# **3 Volt Intel<sup>®</sup> Advanced+ Boot Block Flash Memory**

**28F800C3, 28F160C3, 28F320C3, 28F640C3**

*Specification Update*

Order Number: 297938-014

## 2. 28F320C3xC Reset Failure

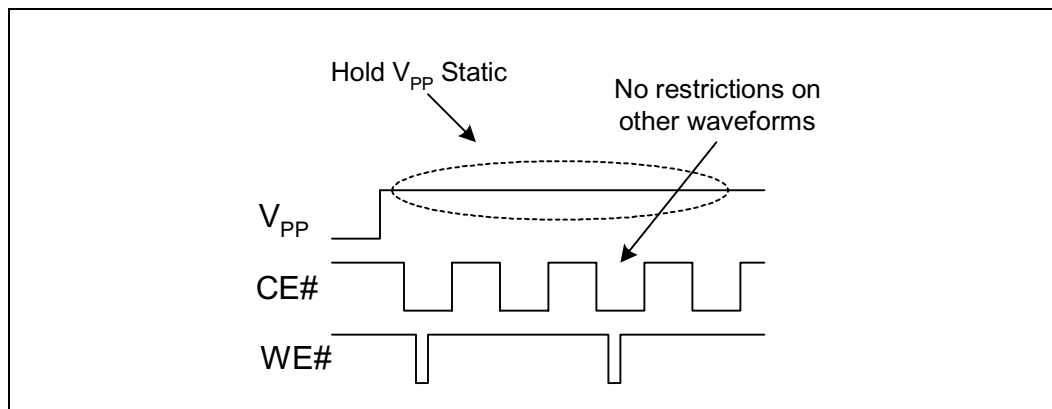
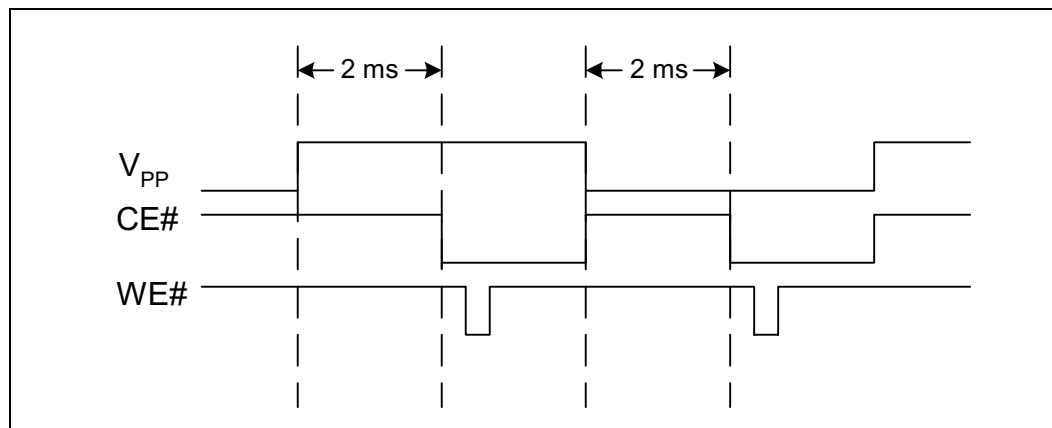
**Problem:** The 0.18 $\mu$ m 28F320C3xC devices can unintentionally reset under certain conditions where  $V_{pp}$  toggles.

**Implication:** When the reset occurs, any command being executed is interrupted and the flash switches to read array mode.

**Workaround:** There are four workarounds for this erratum:

- 1) Tie  $V_{PP}$  to  $V_{CC}$ ;
- 2) If the third and fourth digits on the top side FPO mark (third line) is equal or greater than “23”, then  $V_{CC}$  may be set from 2.7v to 3.3v.  $V_{CC}$  must not exceed 3.3v
- 3) Set  $V_{pp}$  to a static high or static low level as shown here; and

4) Wait 2 ms after a  $V_{PP}$  transition to access the flash device, as shown here.

Figure 1. Workaround Placement

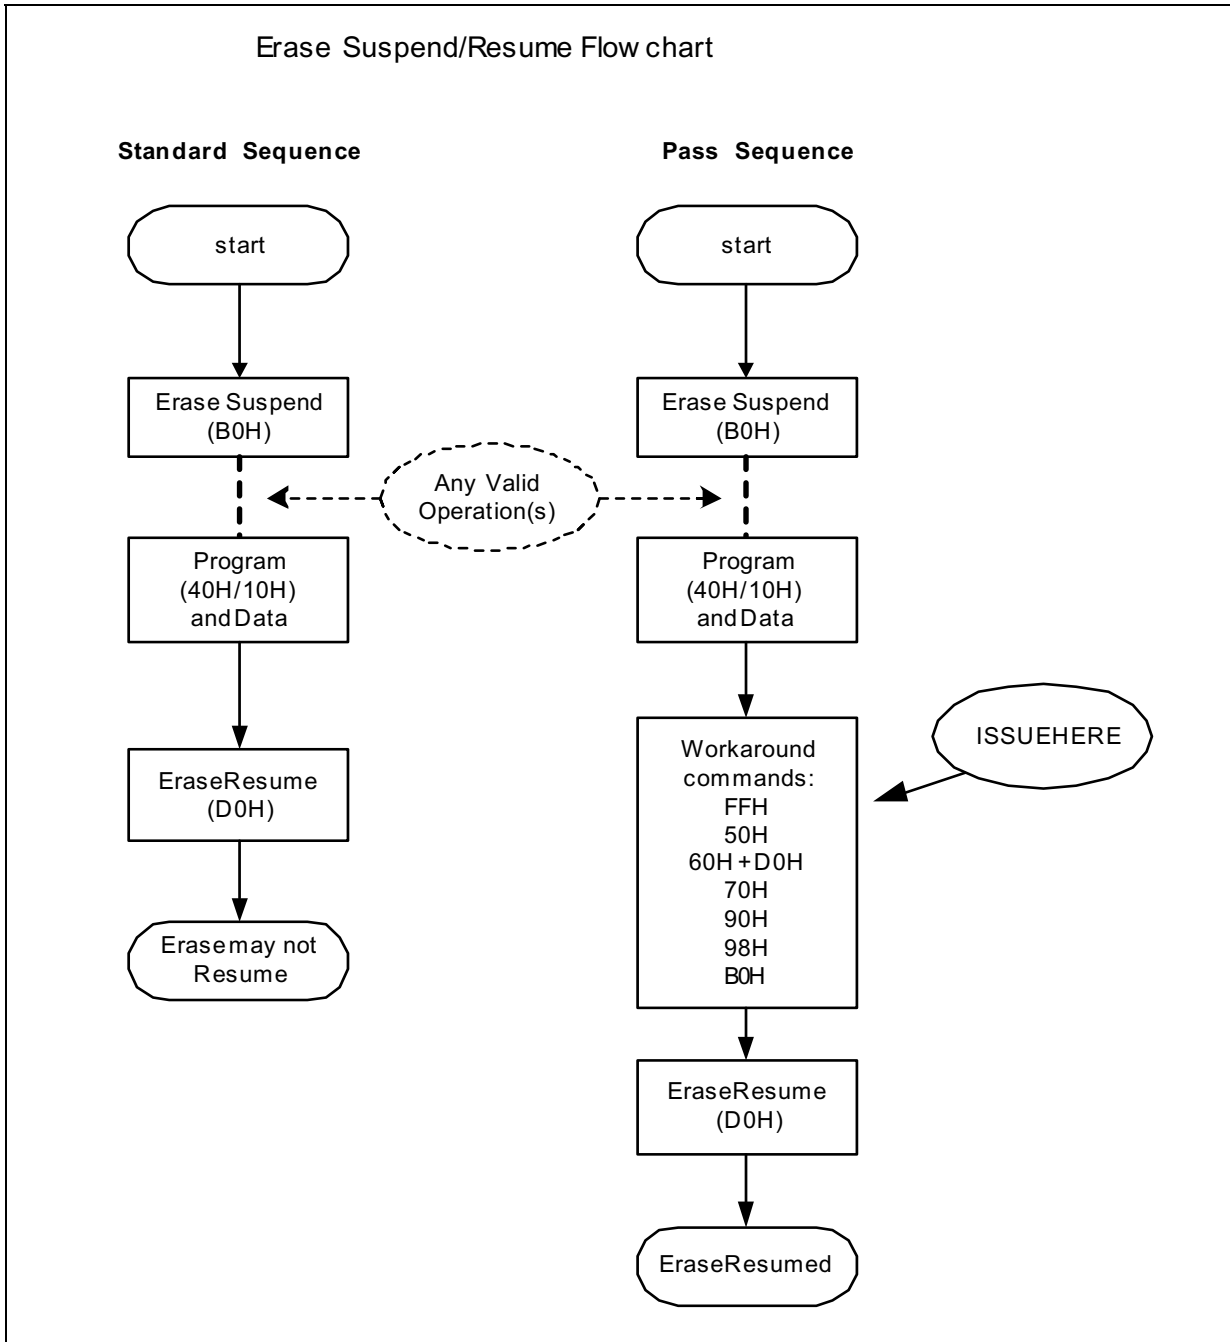
**Problem:** On the 0.18µm 28F160C3xC devices, a design anomaly was discovered. During an Erase-Suspend operation, if the Program (40H/10H) sequence is executed, under limited conditions the proceeding Erase Resume command (D0H) may not actually resume the device. No customers have reported failures in product applications. Customers who use any version of FDI (Intel Flash Data Integrator) software will not see this issue. If the Read Array command is issued prior to the Erase Resume command, users will not see the issue (typical in XIP applications).

**Implication:** The Resume Command (D0H) may be ignored by the device and will not correctly resume. The device will appear to remain in suspend (via status register). After a reset of the flash device the status register will clear. This failure has been recreated in a lab environment only.

1. If FDI (Intel Flash Data Integrator) software is used, users will not see the issue.
2. During an Erase-Suspend (B0H), user must issue any of the following commands after issuing the Program (40H/10H) and data sequence but before issuing the Erase-Resume (D0H) command.

**5. 28F160C3xC and 28F640C3xC Lock/Unlock/Lock-Down Operation**

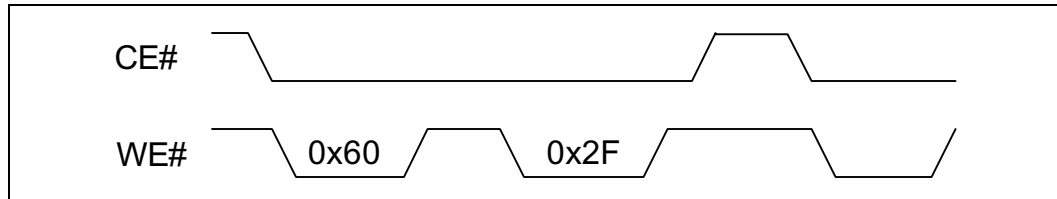
**Problem:** On the 16Mb and 64Mb 0.18µm devices, if CE# is deasserted after any block lock operation and before the next write sequence, the part may perform the same operation on additional blocks. (See waveform below.)

**Implication:** When CE# is deasserted after performing a block lock operation to a specific block and prior to the next write sequence, other blocks may perform the same operation.

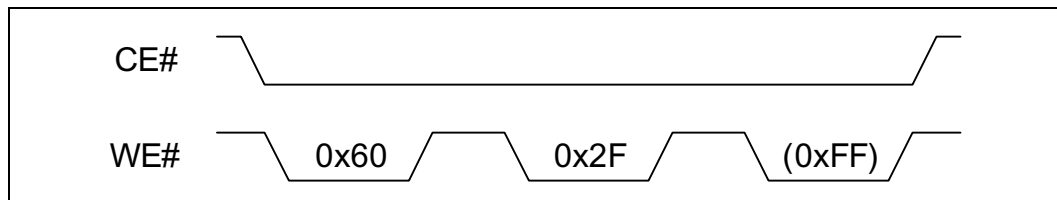
Immediately after performing a block lock, unlock, or lock-down operation, perform a valid write sequence before chip enable (CE#) is deasserted.

- 1) Assert CE# and toggle WE# to write the block lock setup command (0x60).
- 2) Toggle WE# a second time to write the confirm command (lock = 0x01; unlock = 0xD0; lock-down = 0x2F).
- 3) Toggle WE# a third time (ex: 0xFF- Read Array) before CE# is deasserted. (See waveform below.) Any other valid write sequence will also work (i.e., 0x90 - Read Configuration, 0x40 - Program, 0x20 - Erase).
